TITLE OF PROJECT: **Anthony Hall – Replace Elevators 1, 2, 3 and 4**

PROJECT NUMBER: CP23041

ADDENDUM NO: 1

Addendum No.: **One (1)**

ADDENDUM #1

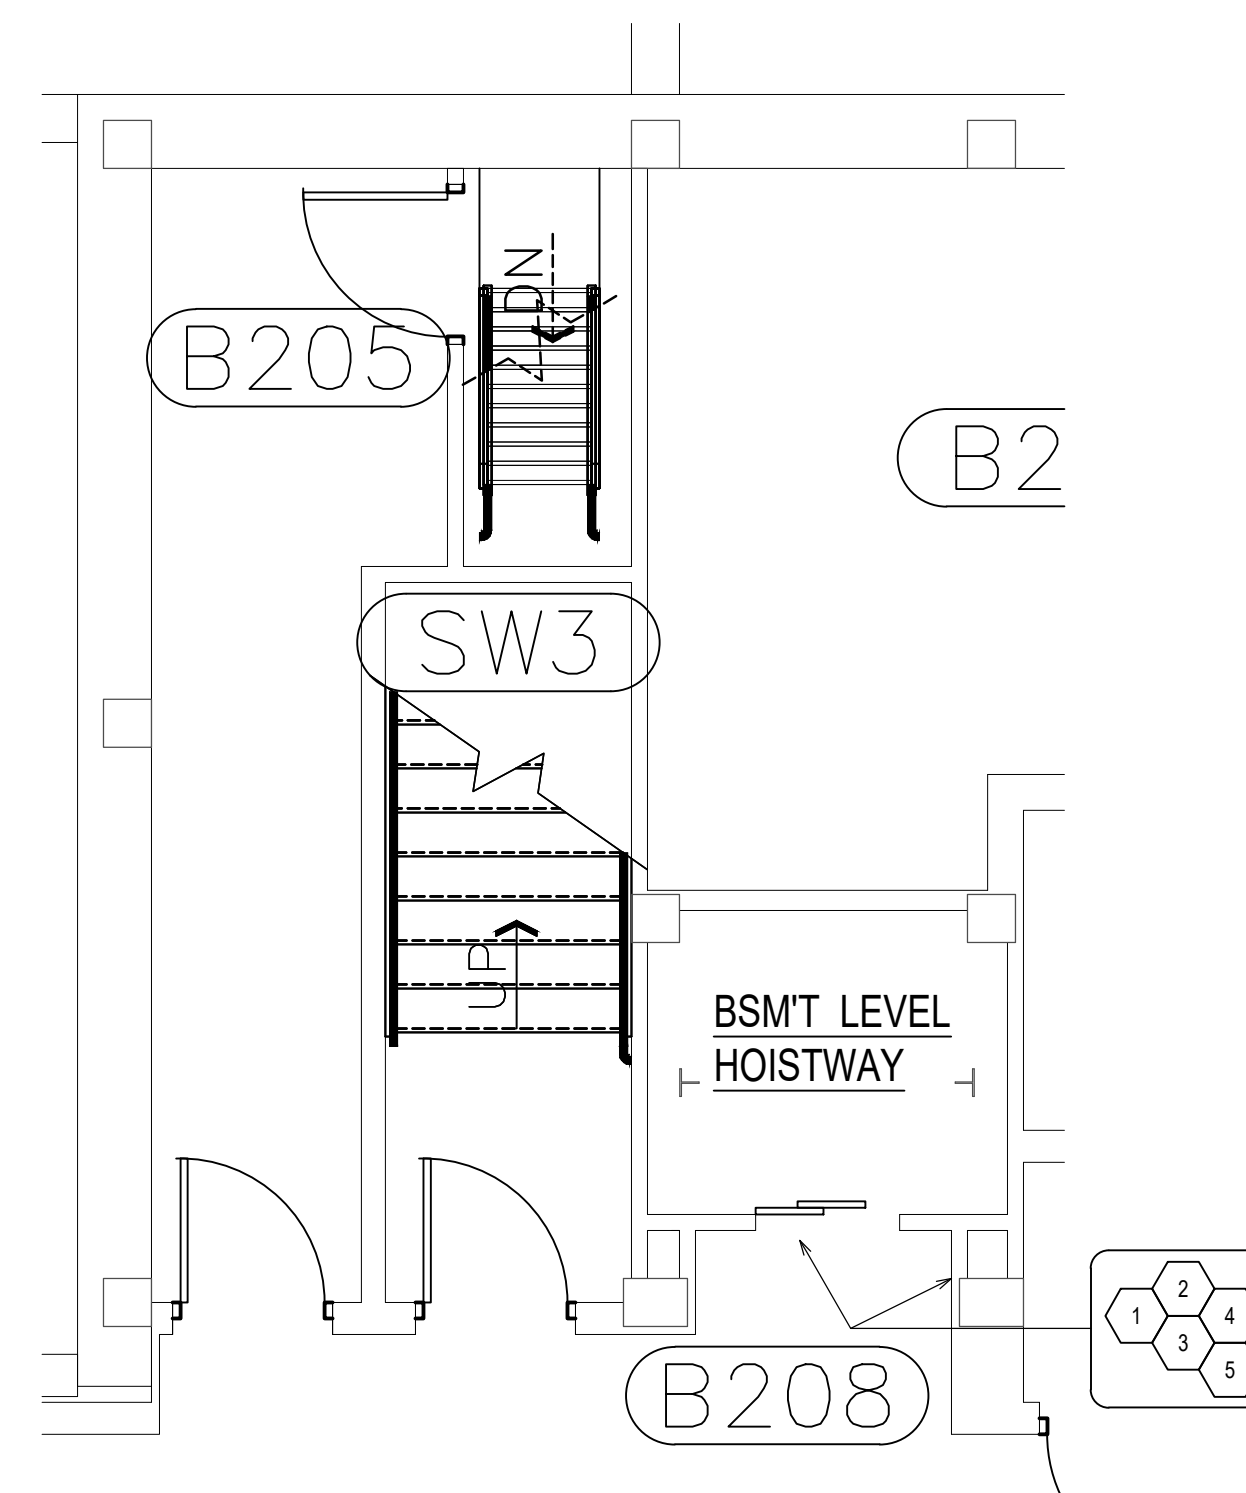
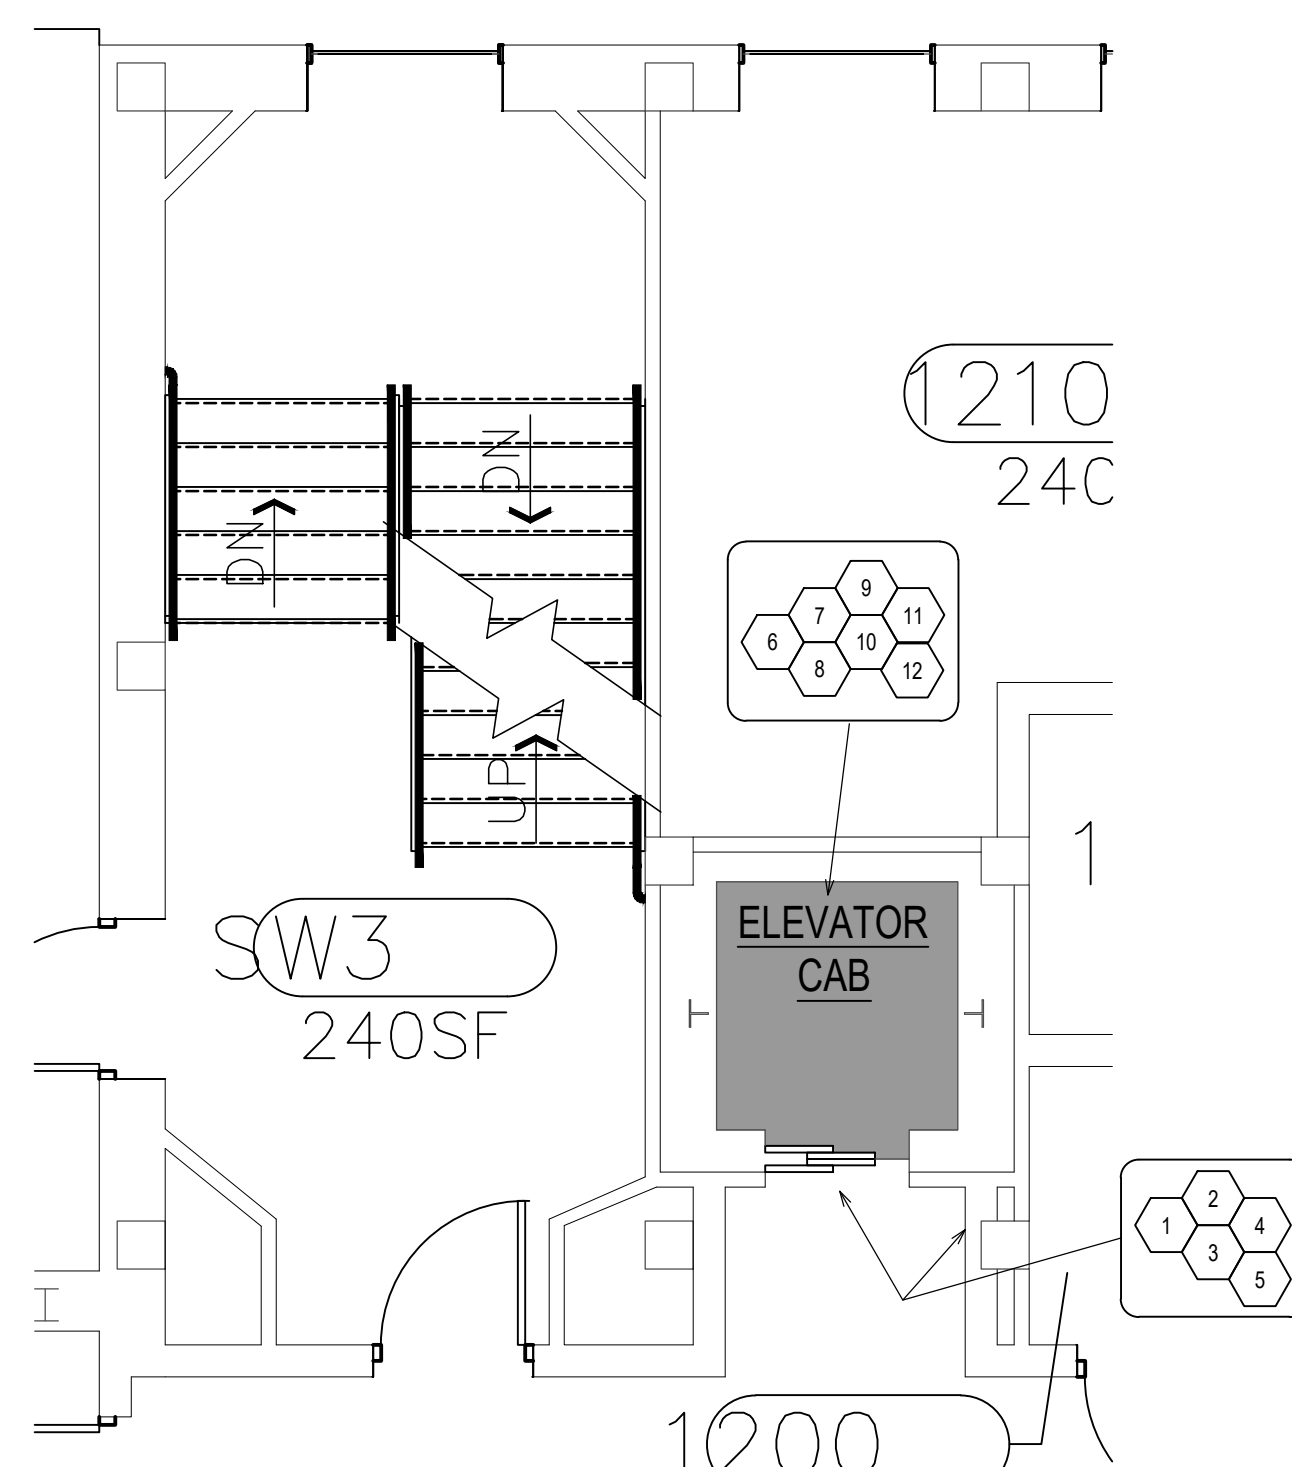
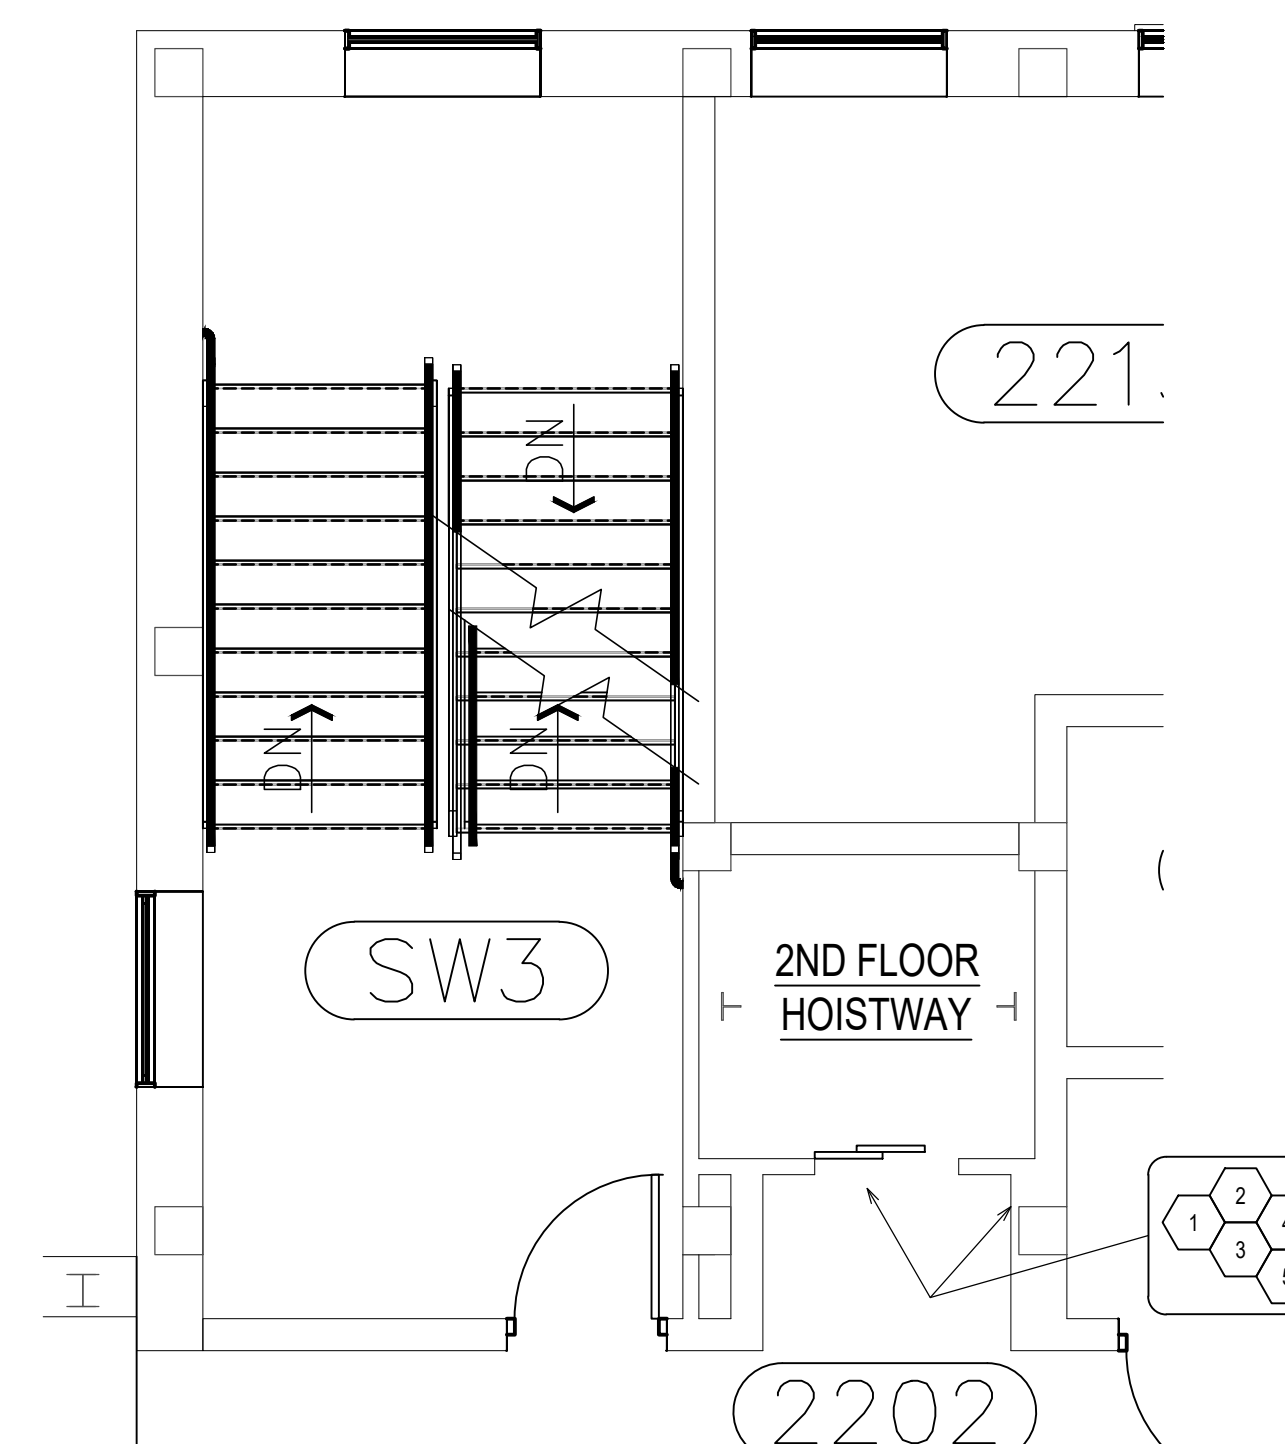
Item #2 **Reference:** *Drawing Sheet A2.1 and A2.2 (issued)*

The original drawing sheets referenced above included the incorrect schedules. The above drawing sheets listed containing an Addendum date of 2023.11.01 are issued with this Addendum with the correct schedules.
